Subject: Revised Responses to US-APWR DCD RAI No.744-5668 Revision 2 (SRP 19.0)

Revised Responses to Request for Additional Information
No.744-5668
Revision 2

US-APWR Design Certification

RAI NO.: NO. 744-5668 REVISION 2
SRP SECTION: 19 – Probabilistic Risk Assessment and Severe Accident Evaluation
APPLICATION SECTION: 19.1
DATE OF RAI ISSUE: 04/27/2011

Figure 1 Revised MCR Event Tree

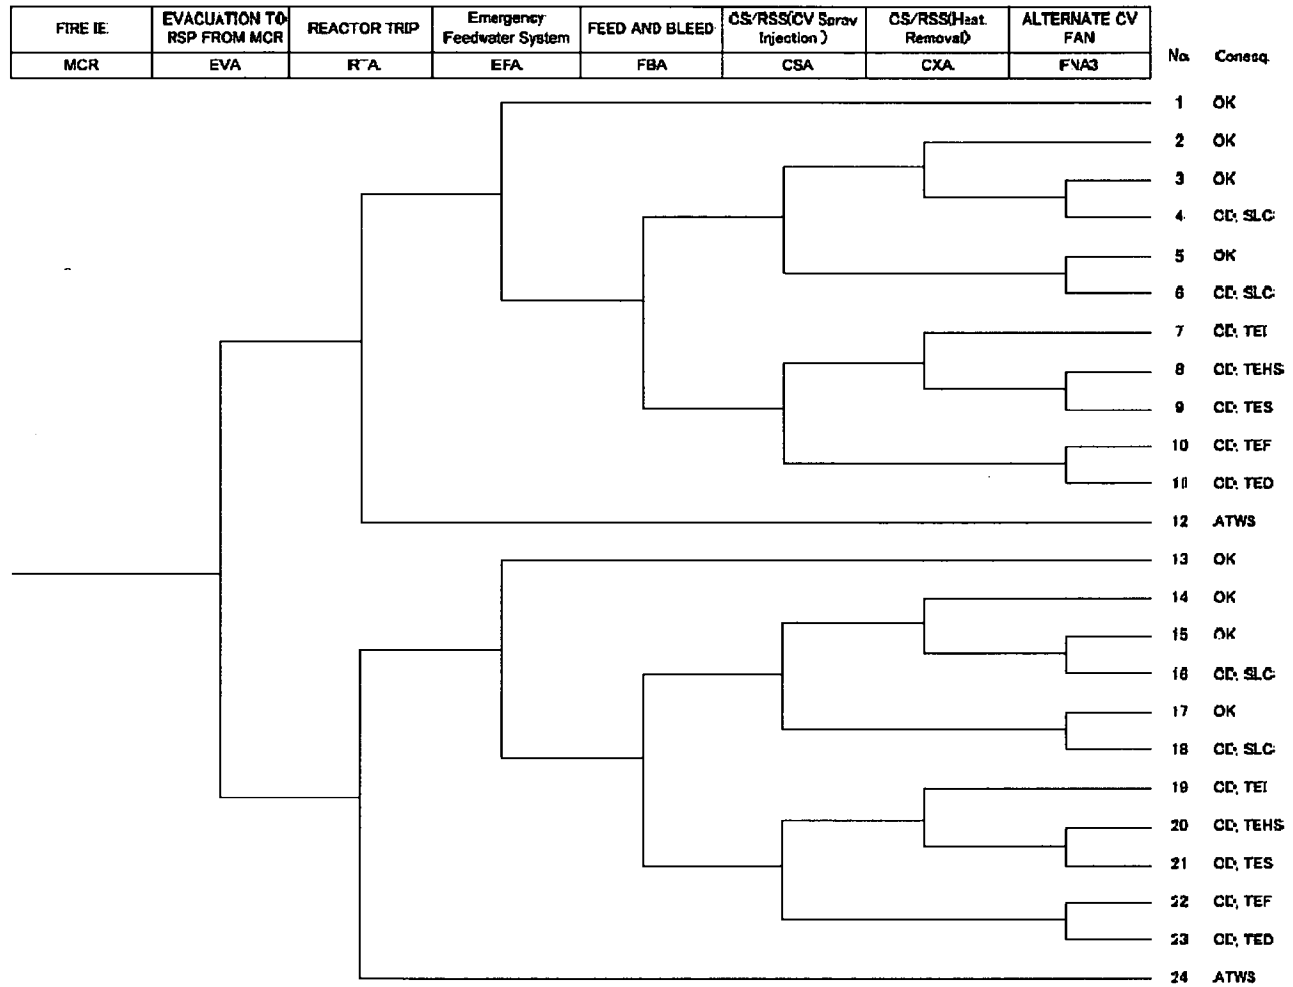
(Follow-up to Question 19-462) Please (a) describe in more detail and provide the failure probability of top event "EVA - Evacuation to RSP from MCR," (b) provide the accident frequencies of main control room sequences shown in Figure 1, and (c) explain why both success and failure paths of top event EVA are identical.

(a) Description of top event "EVA - Evacuation to RSP from MCR"

Top event heading "EVA" means fraction of evacuations from the MCR to the RSC room for MCR fires. "Challenging fire" for MCR shown in Table C-4 of appendix C of NUREG/CR-6850 will cause adverse effect to environment in MCR. The MCR "Challenging fire" may force the operators to evacuate from MCR to RSC room.

(b) Accident frequencies of main control room sequences shown in Figure 1

Each sequence of the MCR event tree in Figure-1 is as follows. The accident frequencies are results from the internal fire PRA in DCD Revision 3. The fire PRA model is updated according to the internal event PRA model.

Accident Sequence Number of MCR-ET	CDF(/RY)
4	3.8E-13
6	5.5E-12
7	3.4E-10
8	2.7E-14
9	3.9E-15
10	9.9E-13
11	4.2E-12
16	7.8E-13
18	5.0E-12
19	8.1E-09
20	6.8E-13
21	1.1E-13
22	1.1E-11
23	8.5E-12

(c) Reason why both success and failure paths of top event EVA are identical

Figure 1 MCR event tree has been developed to quantify sequences for both operations at the MCR and at the RSC. The sequences of the event tree after the upper branch of top event "EVA" are for the MCR and the sequences after the lower branch of "EVA" are for the RSC. The success and failure paths of top event EVA are identical because the RSC has the same functions and capabilities for the safety VDUs at the operator console (OC) in the MCR, and all equipment that is operated from the safety VDU of the OC in the MCR can be operated from the RSC.
